ADDENDUM '02'

Project Name Collingwood Green Phase 3
Toledo, Ohio

Addendum Date: February 13, 2017

UTILITY CROSSING TABLE

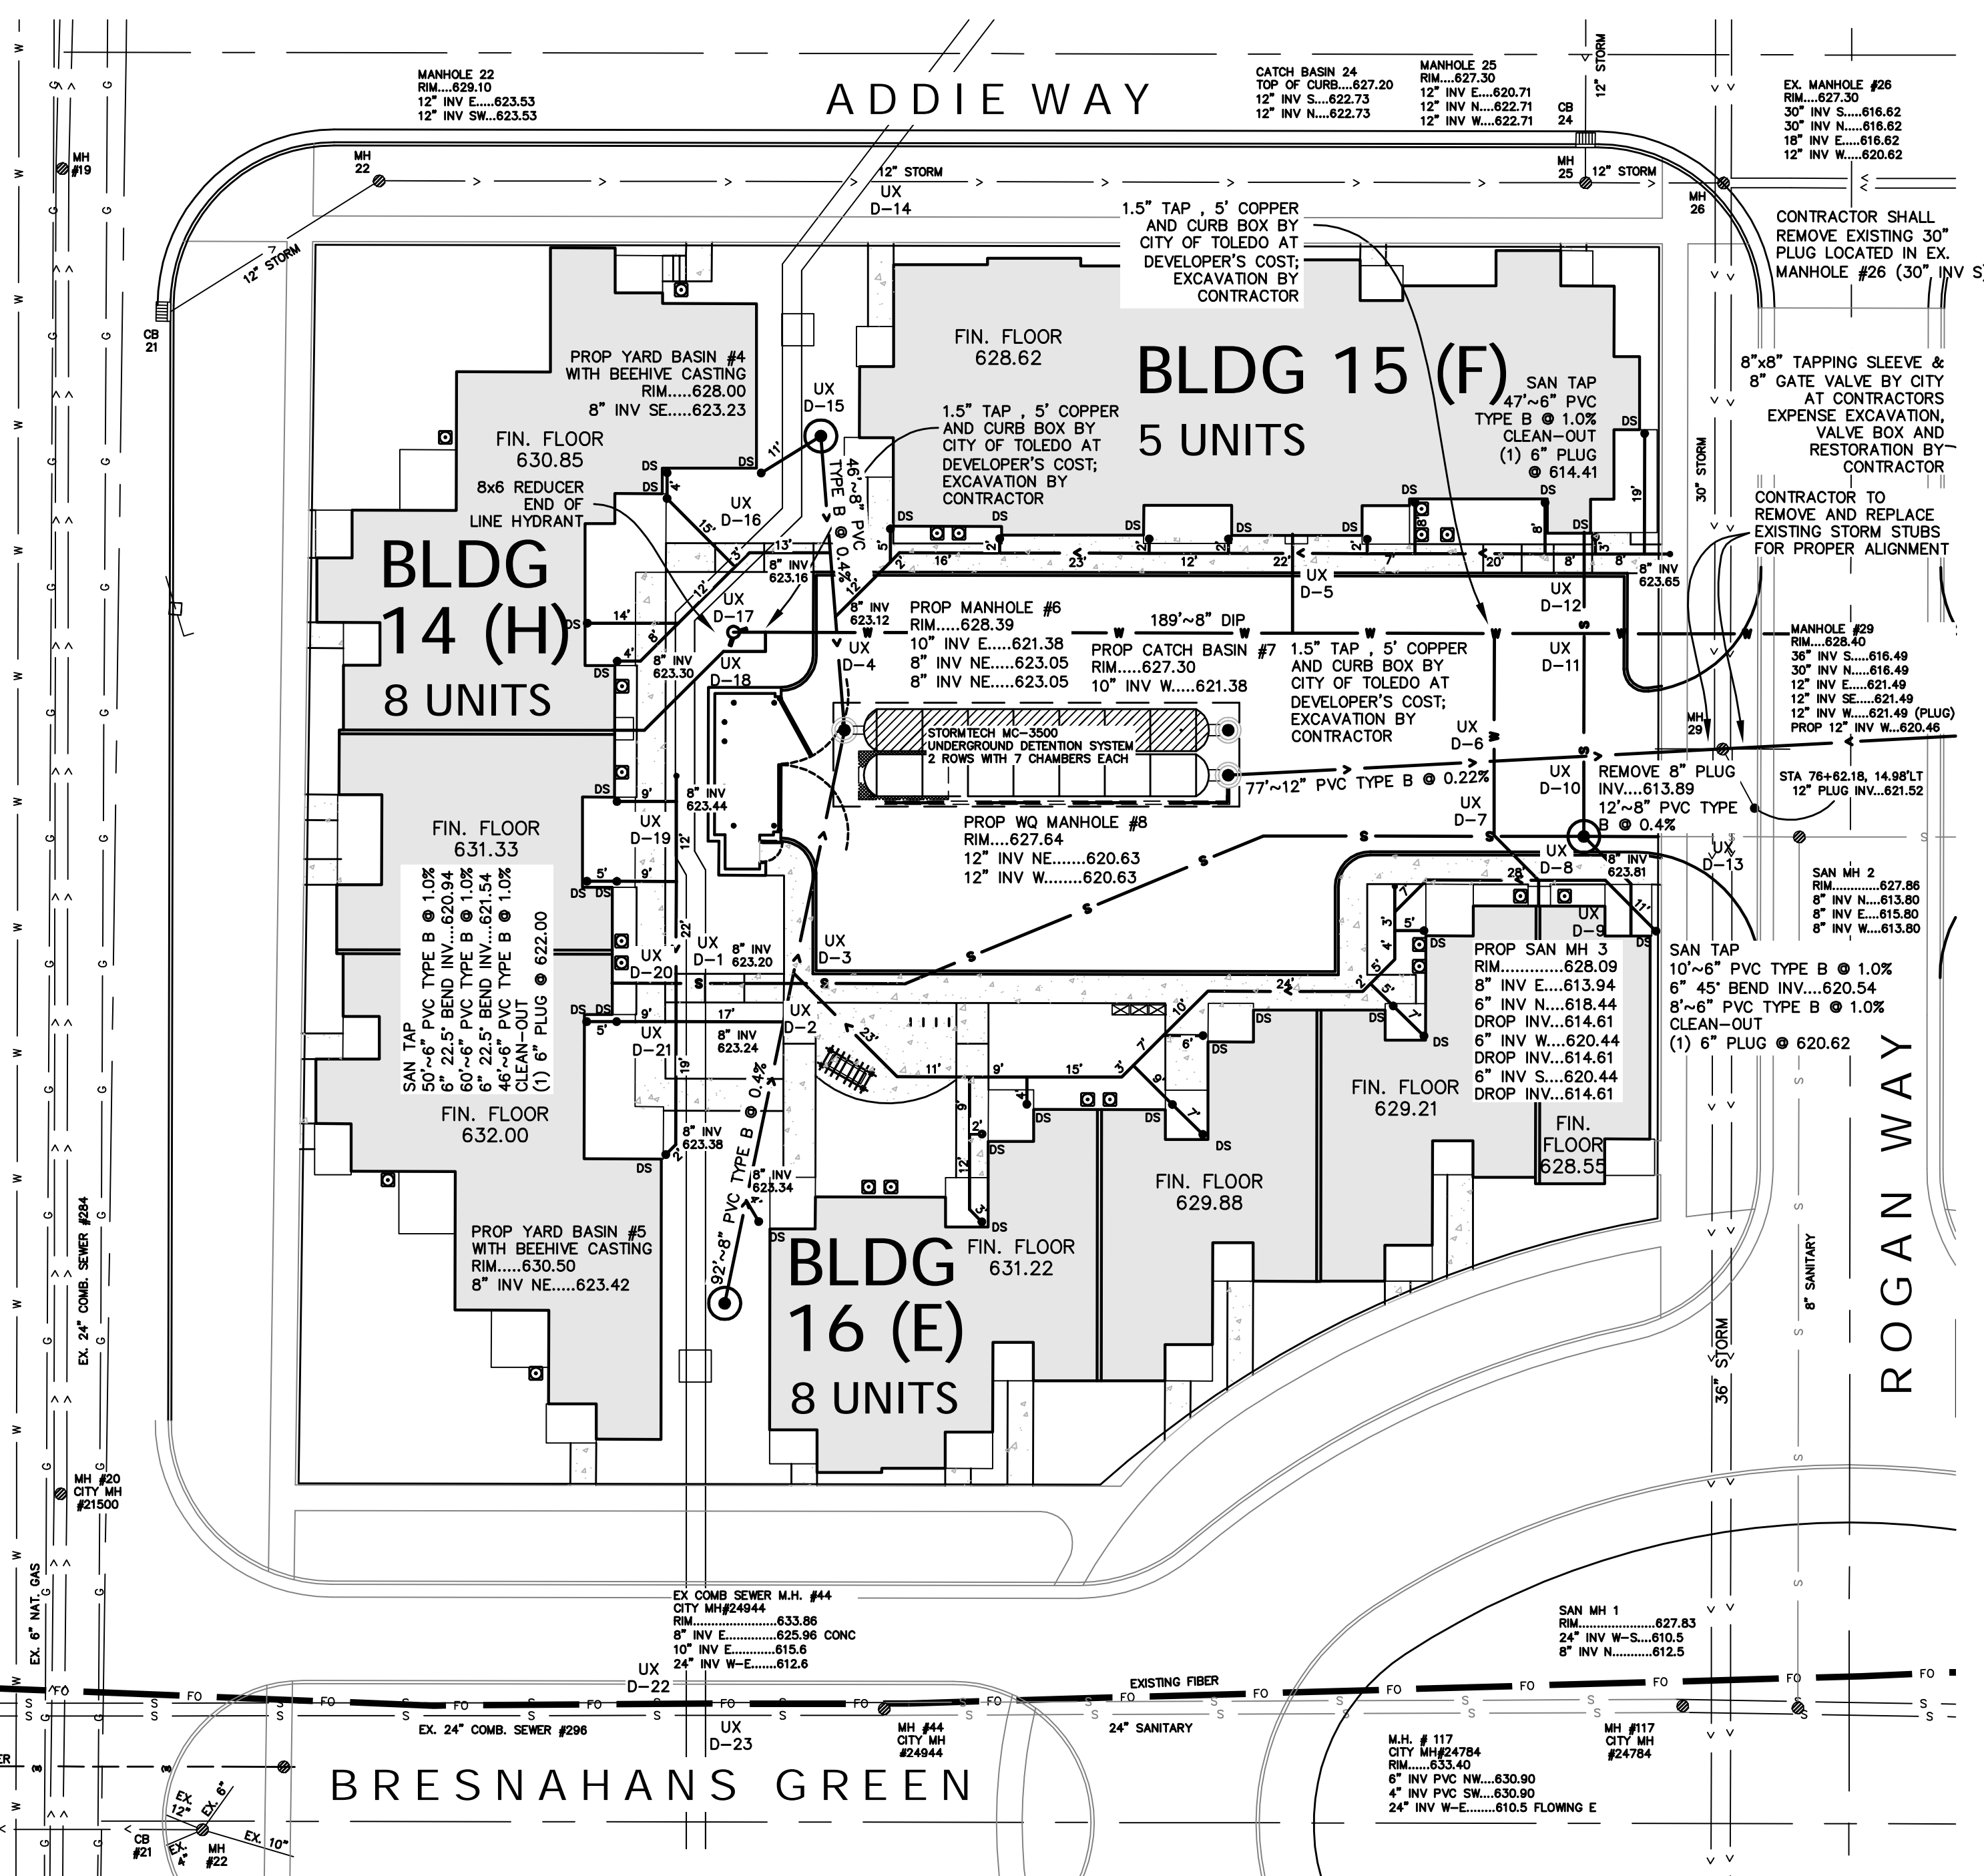
- 1. BLOCK C PROPOSED UTILITIES Sheet 9/17 – Utility crossing tables were updated to include the duct bank
- 2. BLOCK D PROPOSED UTILITIES sheet 13/17 – Utility crossing tables were updated to include the duct bank

second floor framing plan

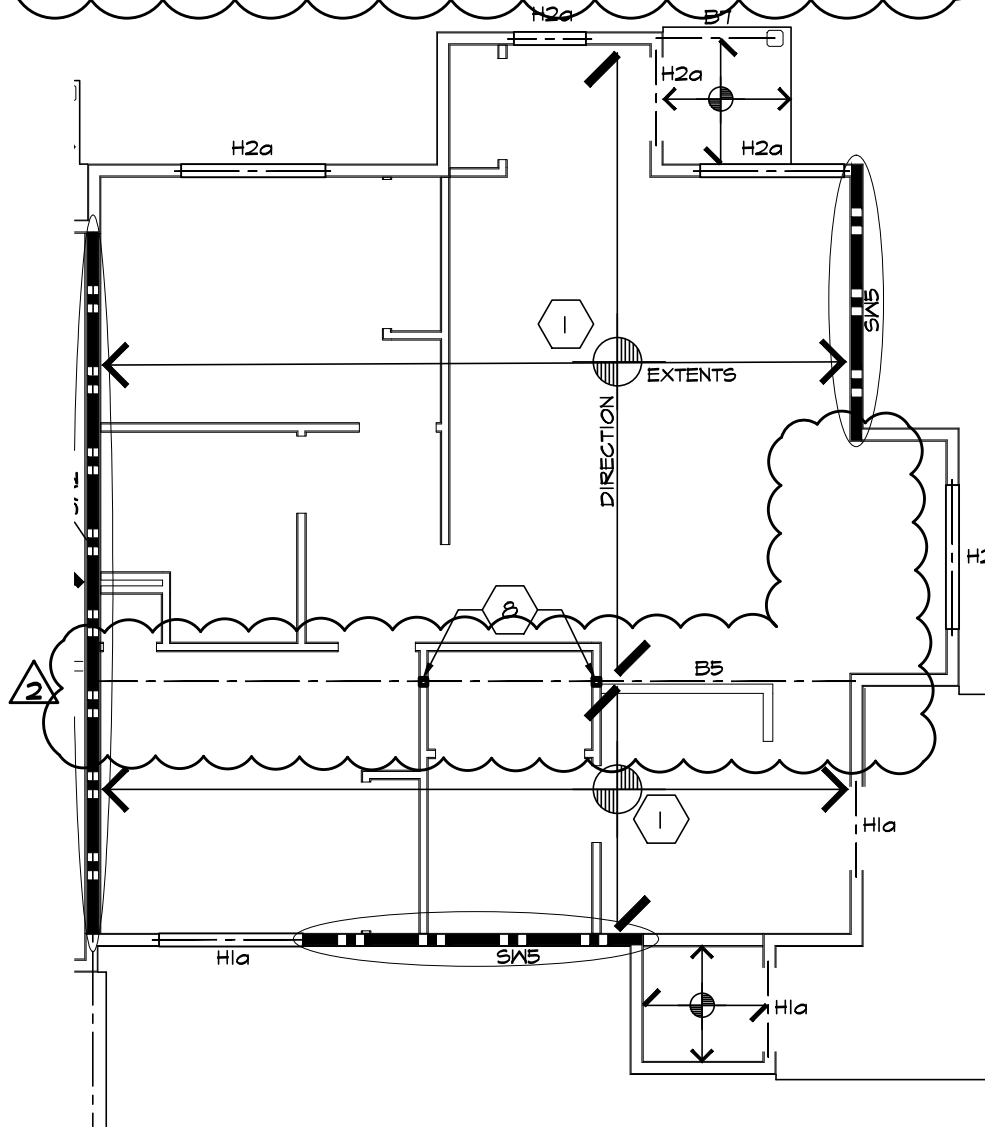
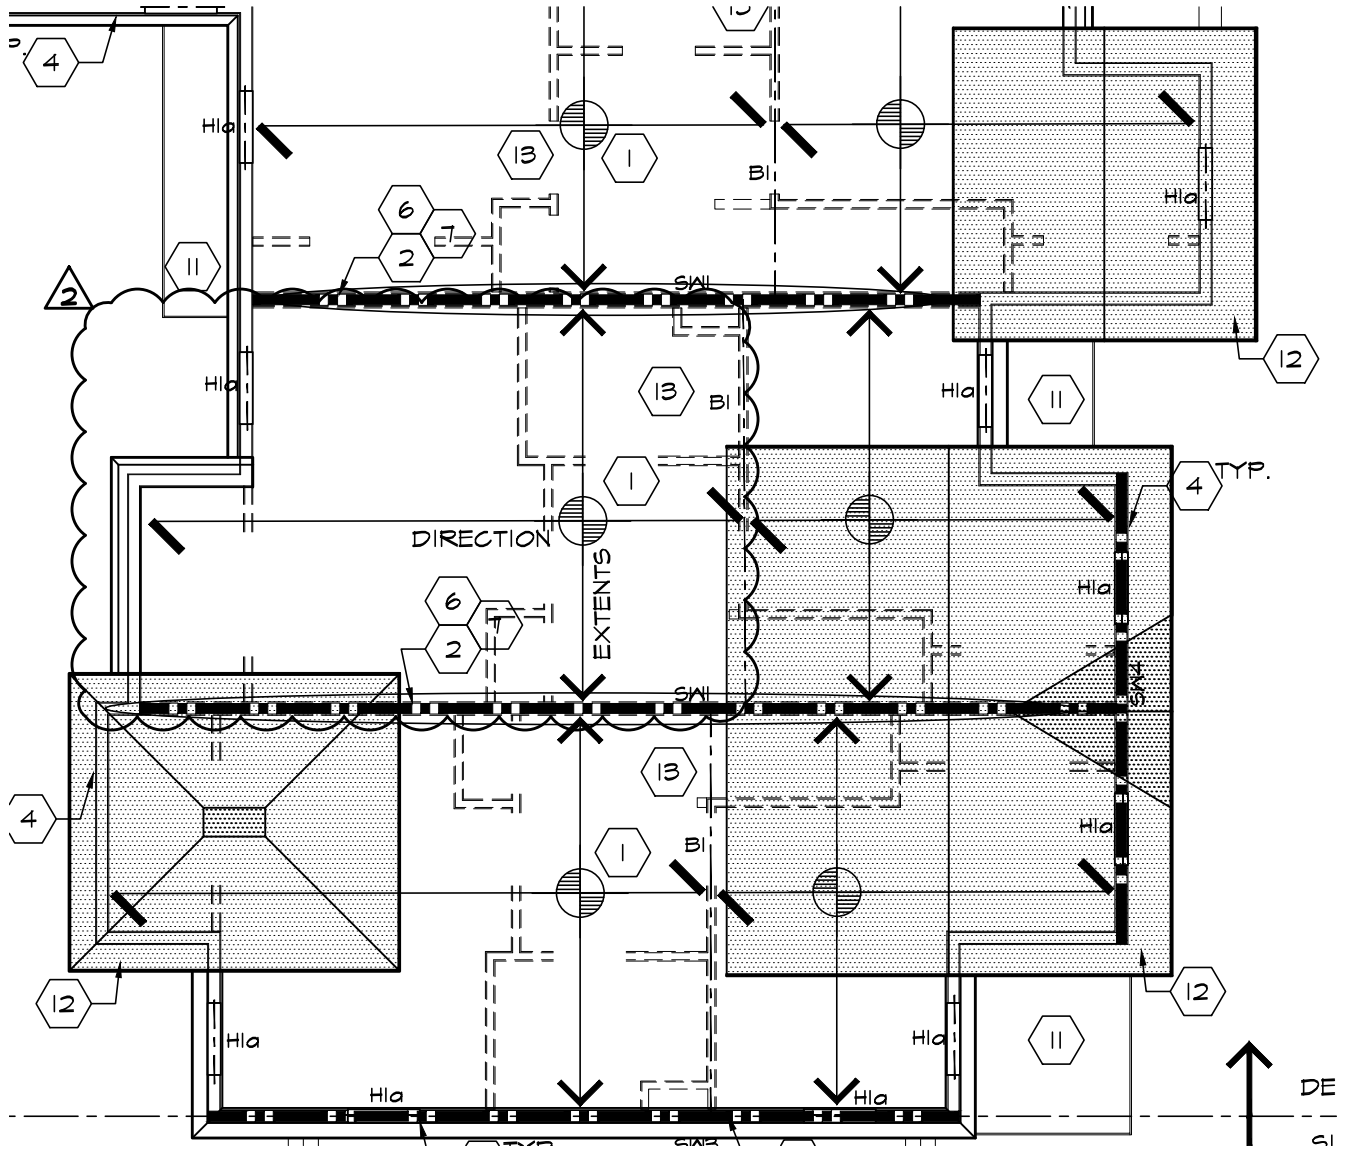
- a. Changed beam B4 to Beam B5 and moved to be aligned with outside wall, and revised roof truss profile – see building section A/A502.
 - b. Added coded note 8 to identify wood framed column with column base cap and top cap for attachment to slab on grade and to beam B5.

Addendum 02 - ROOF PLAN
BUILDING 'B'

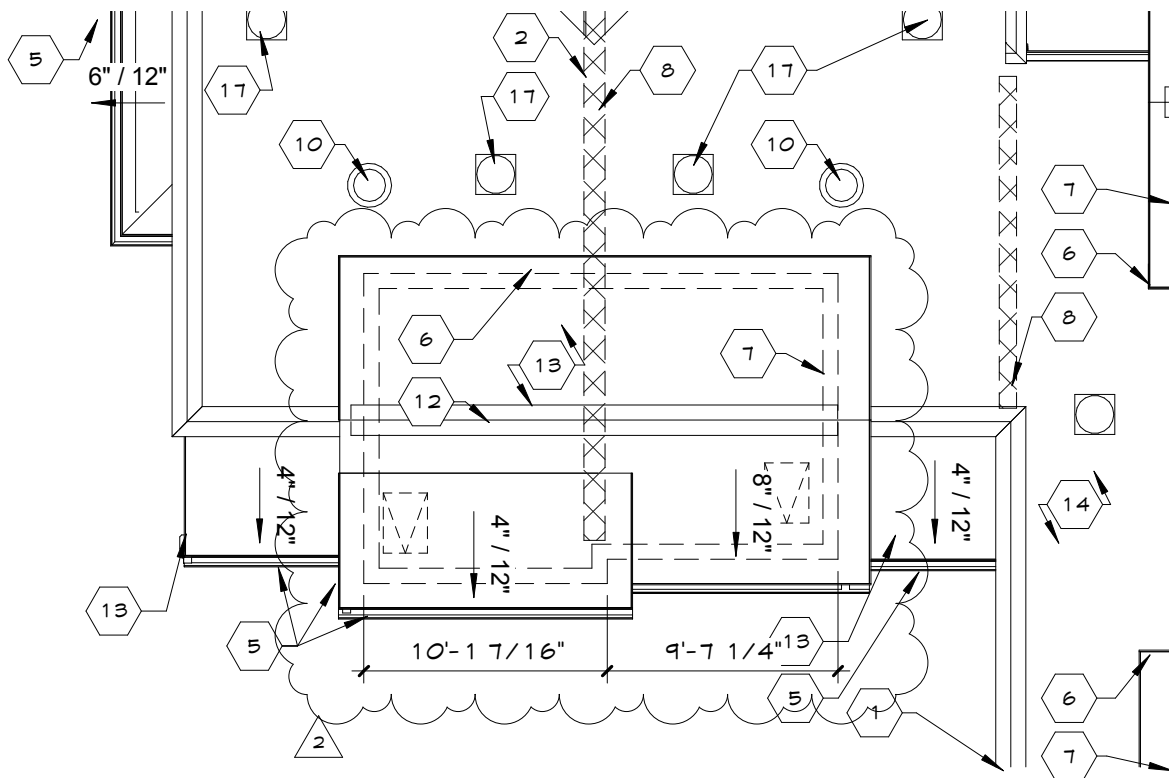
8. Sheet A102A:
 - a. 3 windows indicated as '?' to be type 'K'.
9. Sheet A103B and A103E
 - a. Revise shed roof areas. See attached sketch
10. Sheet A101E

Addendum 02 - 1ST FLOOR
BUILDING 'E'

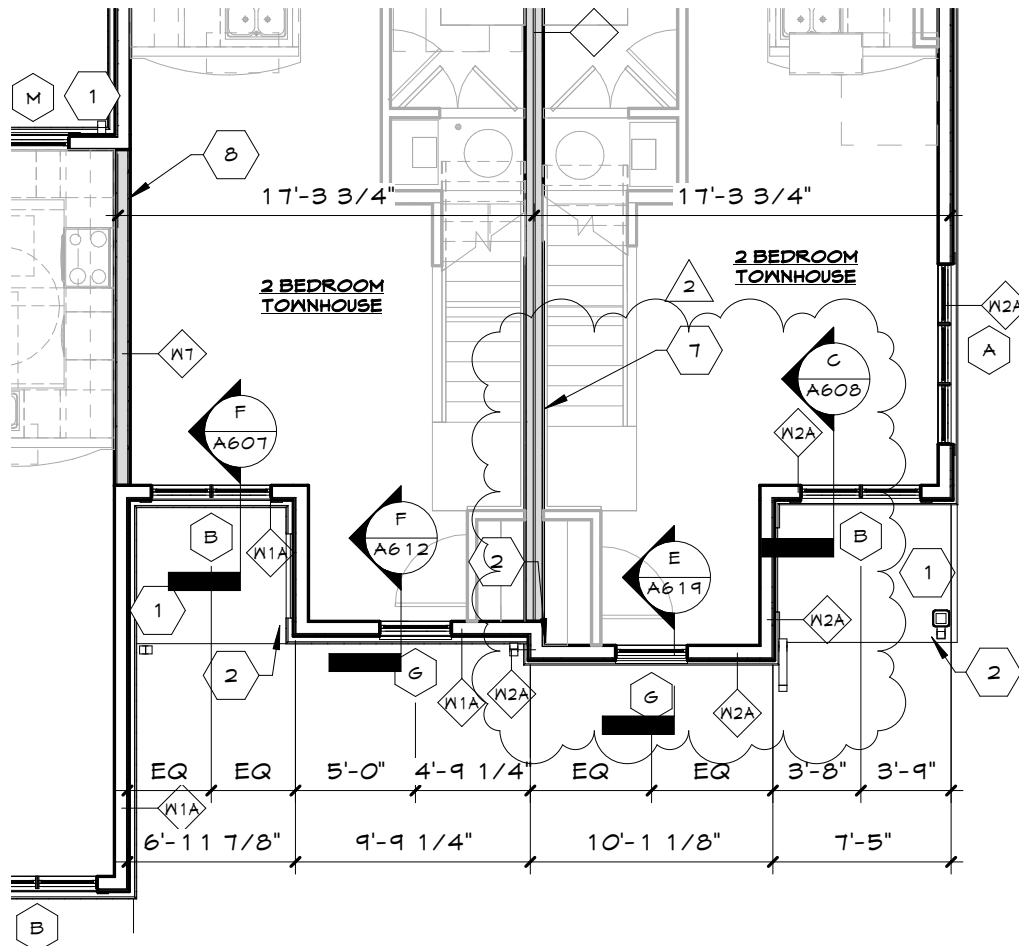
- a. Revise wall type tags. See attached sketch
11. Sheet A102E
 - a. Revise wall type tags
 - b. Revise window types. See attached sketch
